REQUEST FOR TECHNICAL REVISION (TR) COVER SHEET

File No.: M- 410-1977 Site Name: Cross Gold Mine
County Boulder TR# 12 (DRMS Use only)
Permittee: Grand Island Resources, LLC
Operator (If Other than Permittee): _____
Permittee Representative: Daniel Takami

Technical Revision #12 (TR12) Grand Island Resources, LLC (GIR) proposes changes to the Cross Mine site, including replacing the Cross Mine Snowshed and relocating the Water Treatment System. The mine site is near Nederland, Colorado. The changes involve constructing

Figure 2.1 – Oblique View of Proposed Facilities

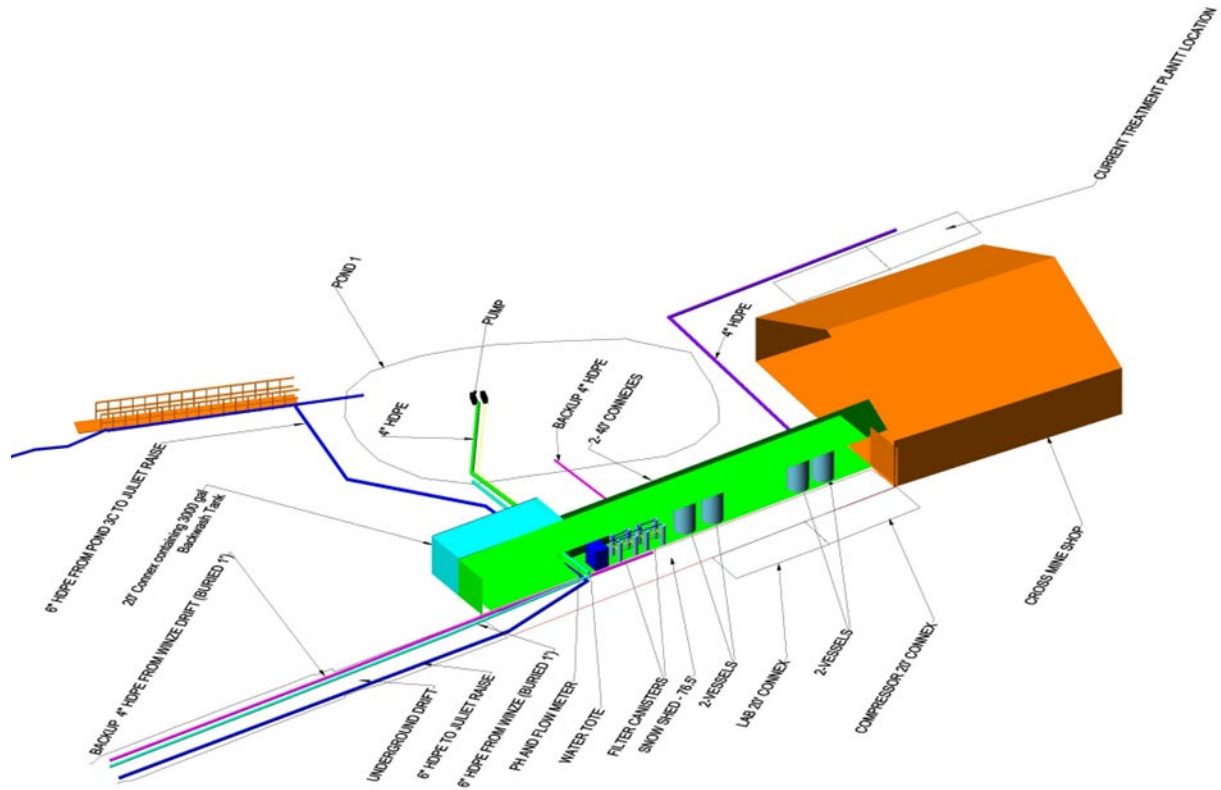
The existing water treatment system, housed within connexes, will undergo a relocation process, and will be strategically positioned between the replacement snowshed and the existing Pond #1. Importantly, the process will occur without any modifications to the current water treatment operations. The new connexes, designed to house the laboratory equipment and the current compressor, will be placed as illustrated in the oblique view Figure 2.1.

The relocated Water Treatment System will be housed within 40-foot-long connexes, identical to the current system. The proposed location of the connexes is depicted in Figure 2.1.

Figure 2.2 – Replacement Snowshed and Proposed Treatment Plant Location

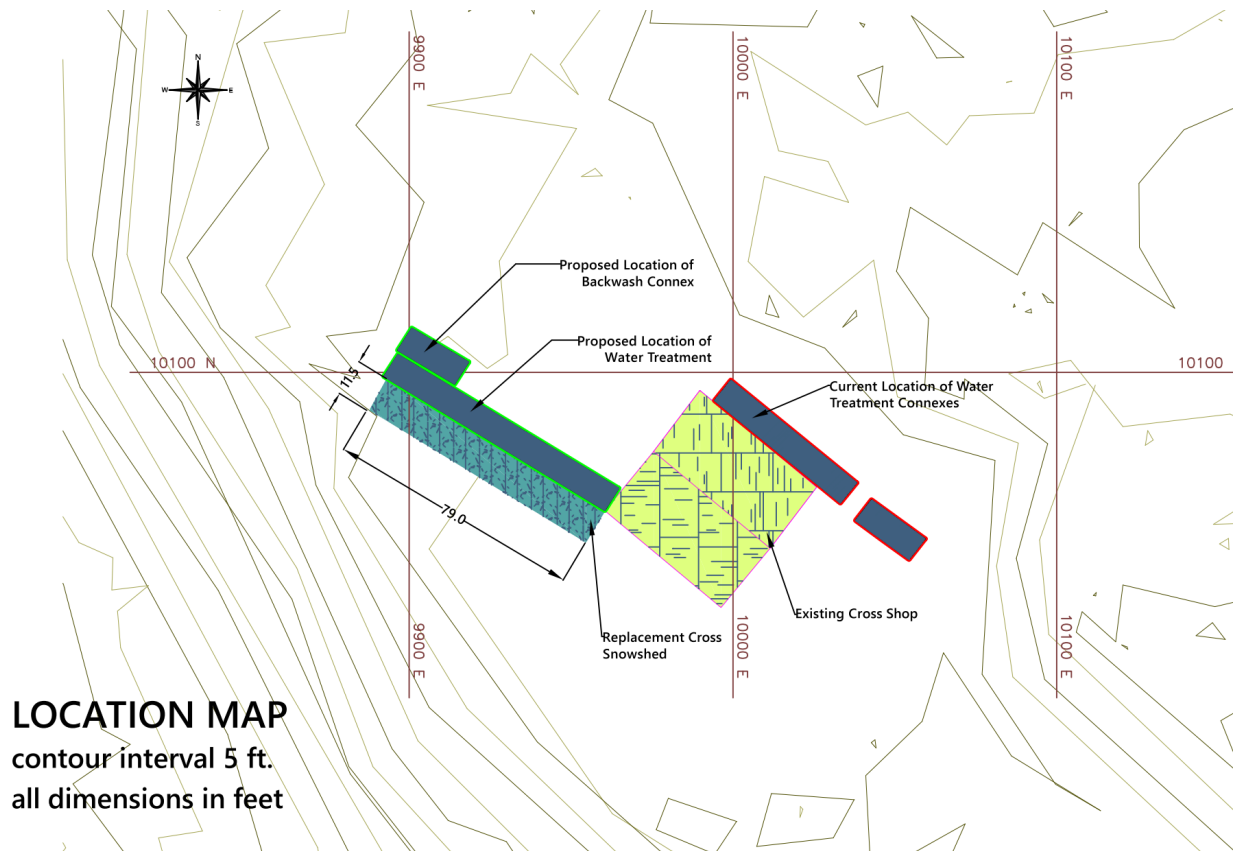
The primary focus of this phase involves the installation of the replacement snowshed, alongside the strategic relocation of the existing water treatment system and the housing for both laboratory equipment and the compressor within new connexes. The replacement snowshed, mirroring the dimensions of its predecessor, will be installed along the same alignment as the previous structure, maintaining a length of 79 feet.

The proposed dimensions and materials for the replacement snowshed are presented in Figures 2.2, 2.3, and 2.4, which illustrate the Snowshed alignment, Cross section and Longitudinal section, respectively.

Figure 2.3 – Replacement Snowshed Materials and Dimensions Cross Section

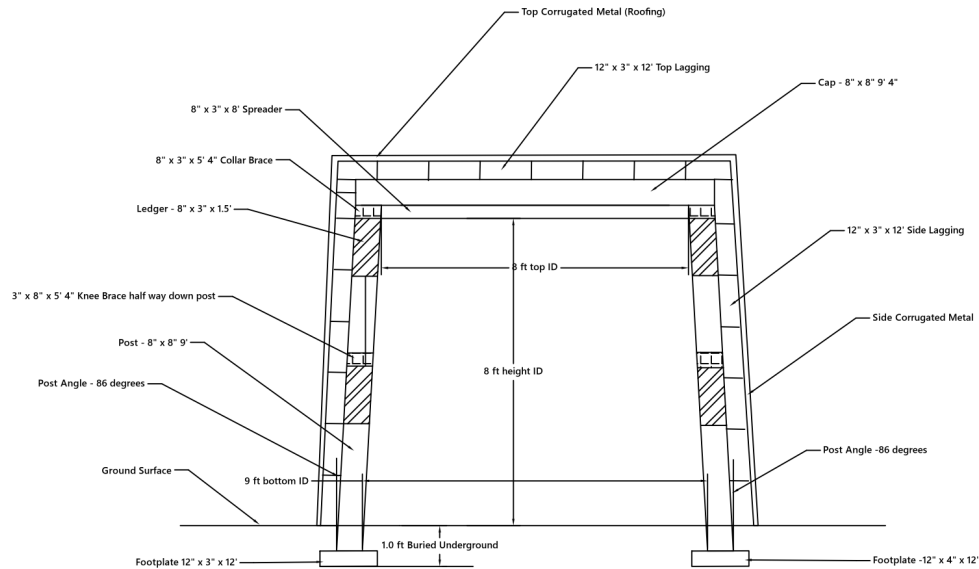
The replacement snowshed will have external dimensions of 79 feet in length and 11.5 feet in width at the base. The total external height from the ground to the top of the galvanized roof will be 8 feet - 11 inches.

The construction materials have been selected based on their approval for the underground ground support. These materials consist of timber sets (8"x8") for the primary supporting structure, top and side lagging (12"x 3"), and ledgers, collars, and knee braces (8"x3"). The roof and siding will be comprised of corrugated metal.
